PREPARED FOR THE URBAN DESIGN COMMISSION AND PLAN COMMISSION

Project Address: 300 S. Bedford Street and 302-304 Dow Court
Application Type: Zoning Map Amendment, Demolition Permit, Conditional Use and Vacation
Legistar File ID # [33437](#), [32924](#) and [33139](#)
Prepared By: Timothy M. Parks, Planning Division
Report includes comments from other City agencies, as noted.

FINDORFF YARDS
CONCEPTUAL MASTER PLAN

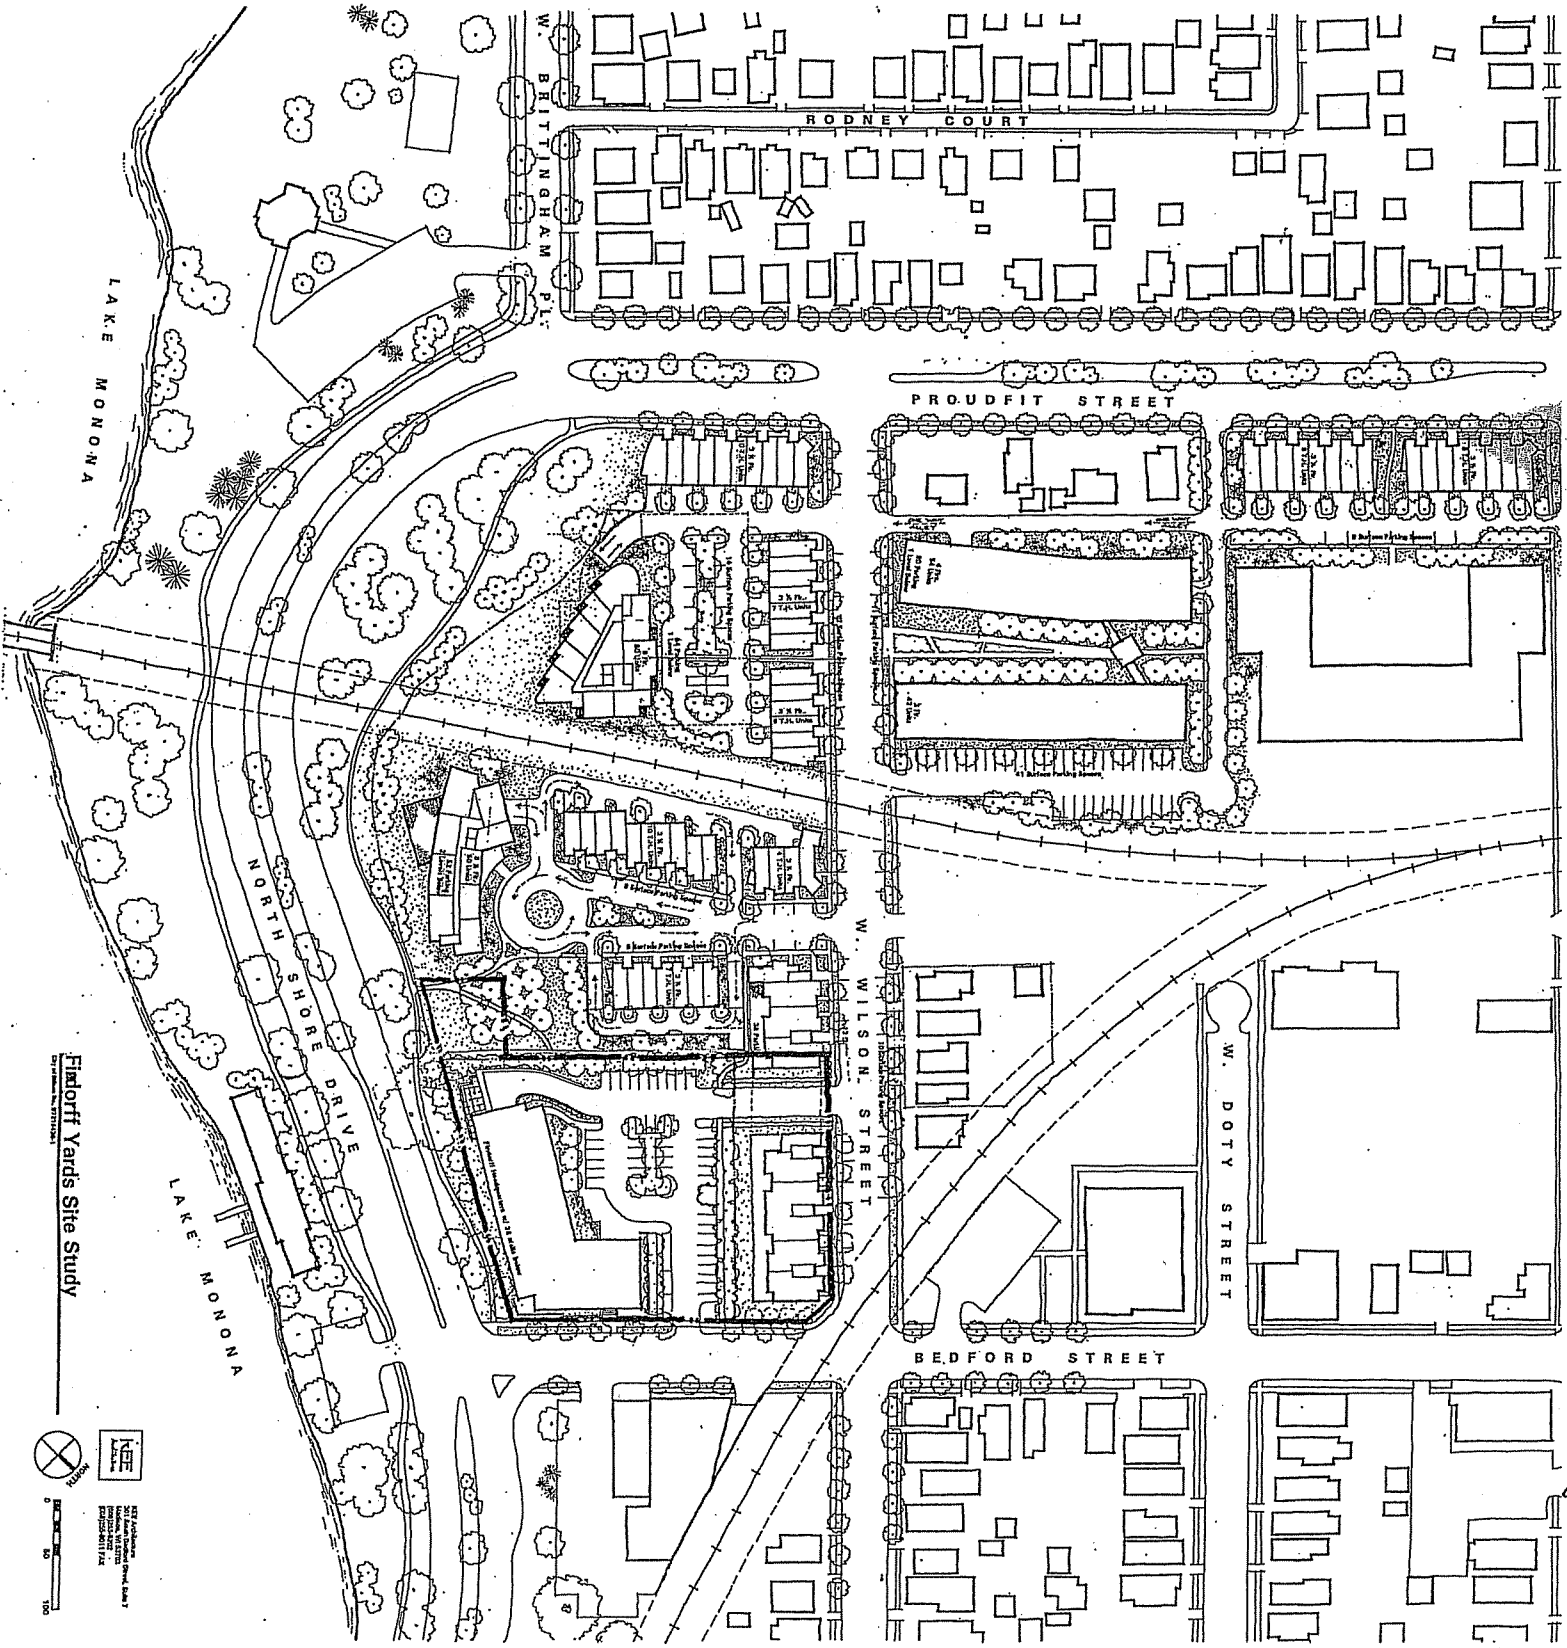
The current proposal represents the continued evolution of the block bounded by W. Wilson Street, S. Bedford Street, North Shore Drive and the railroad/path corridor over the last 20 years. Originally, the Planned Development zoning for the eastern half of the block called for between 28 and 40 dwelling units to be constructed in one or more buildings along the W. Wilson Street frontage of the site where the NCBE office building is now, which replaced an older, smaller office building. At the time that the plans were presented for the Findorff headquarters to the south, two concept plans for the site and the rest of the Findorff ownership west of the site were developed. Findorff, which historically controlled most of the properties extending from S. Bedford Street west to Proudfit Street between W. Main Street and North Shore Drive, offered a plan for approximately 475 dwelling units in about a dozen buildings under their ownership known as the Findorff Yards Conceptual Master Plan (attached). That plan area included the former Tobacco Warehouses, which have since been redeveloped as apartment units by Urban Land Interests, and the Fourth Ward Lofts on W. Main and W. Doty streets, which were developed by Todd and Lance McGrath. The Conceptual Master Plan placed an emphasis on medium-density buildings with structured parking similar to Fourth Ward Lofts. The portion of the conceptual plan area where the apartment building is now proposed was shown as a series of three- to four-story residential buildings with under-building parking and at least 92 dwelling units extending along W. Wilson Street and the railroad/ path corridor in a fashion very similar to the layout of the proposed building.

A second plan for approximately the same area known as the Findorff Yards Site Study (attached) called for the development of approximately 225 residential units in an area bounded by Proudfit Street, North Shore Drive, W. Wilson and S. Bedford streets and included the Tobacco Warehouses. The Site Study placed a greater emphasis on creating a more “neighborhood” feel through more extensive uses of townhouse development (and less emphasis on placing all parking in relatively more expensive underground parking) than the Conceptual Master Plan, though both plans called for a nine-story residential tower overlooking Brittingham Park and Lake Monona to be developed on the portion of the Findorff ownership where North Shore Drive curves around and becomes Proudfit Street. The portion of the site where the apartment building is proposed was identified in the Site Study for the development of townhouse-style buildings west of Dow Court and south of W. Wilson Street, with rear-access garages facing the railroad/ path corridor. A multi-story apartment building was shown at the southwestern corner of this block.
